SP 3-873-005

SERVICE PROGRAM

Replacement of a RH head lamp circuit which can overheat and cause the diode to fail open, causing the head lamp to lose power.

This Service Program provides instructions to remove the connector from the RH head lamp circuit and install a diode harness with two diodes in parallel on certain model year 2014-2017 Xpert vehicles.

Figure 10

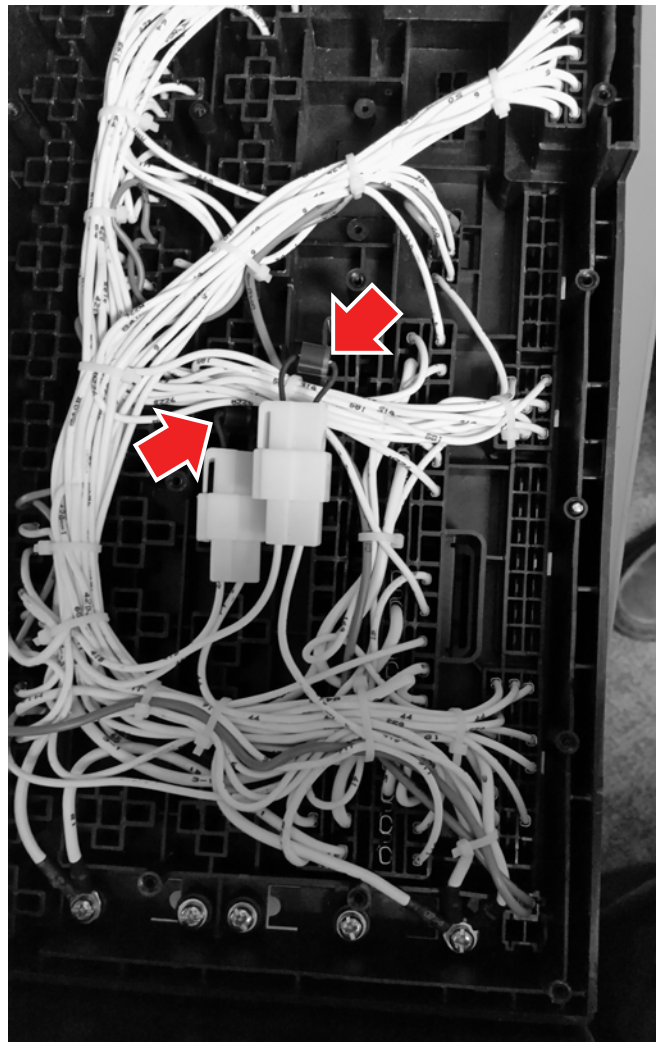
13. Remove the fuse panel access cover and set aside for reinstallation.
14. There are two diodes contained in the fuse panel. Locate the diode and wiring marked with circuit numbers 41B and 41B-1. Cut wire 41B and wire 41B-1 and discard the diode and connector (see Figure 10 and Figure 11).
